RE: <u>Docket No. UE 335</u> – In the Matter of PORTLAND GENERAL ELECTRIC COMPANY, Request for a General Rate Revision.

STAFF EXHIBIT 100

Net Variable Power Costs

Opening Testimony

Figure 2

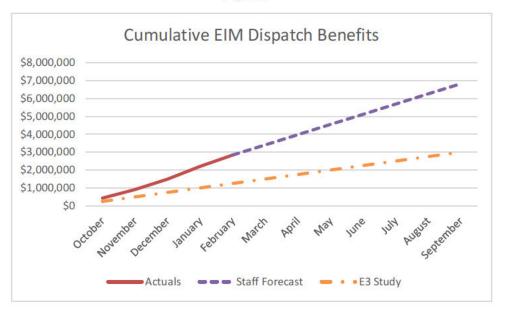
Figure 1, below, shows the difference between Staff's methodology using the current data available and the E3 study. Note that the graph shows the cumulative amount, which is already at the same level as the E3 study after 5 months. Also note that the forecast section will become smaller as time passes.

This method provides a conservative estimate. First, it does not consider any increases in efficiency realized by PGE as it becomes more familiar in operating within the EIM. This is something that PacifiCorp states it has seen as it gained experience operating in the EIM.⁶ Second, the forecast makes no incremental adjustments for further increases to benefits as Idaho Power,

Powerex, and the Balancing Authority of Northern California join the EIM.⁷ Staff's proposal is essentially the same forecast methodology approved by the Commission for PAC's 2018 TAM, without additional new entrant or solar oversupply adjustments. This forecast will provide a more accurate estimate of benefits and currently would result in a \$3.8 million reduction to NVPC.
